This proposal was prepared by the expert from OICA and is based on the existing UN Regulation No. 64. It is aimed at moving the Tyre Pressure Monitoring System provisions in a separate Regulation. It is based on document GRRF/2015/13 taking into account the comments received at GRRF-78. The changes to the text of document GRRF/2015/13 are marked in **bold** and ~~striketrough~~ characters.

"Regulation No. XX

Uniform provisions concerning the approval of vehicles with regard to their tyre pressure monitoring systems

Arrangements of approval marks

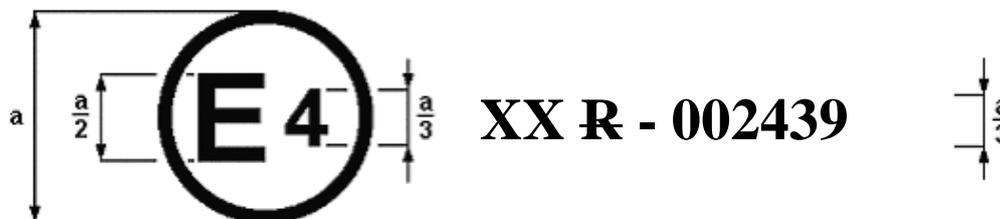
The above approval mark affixed to a vehicle shows that the vehicle type concerned has, with regard to the equipment of a tyre pressure monitoring system, been approved in the Netherlands (E 4), pursuant to Regulation No. [TPMS] under approval number ~~022439~~ **002439**. The approval number indicates that the approval was granted in accordance with the requirements of Regulation No. [TPMS] in its original form.
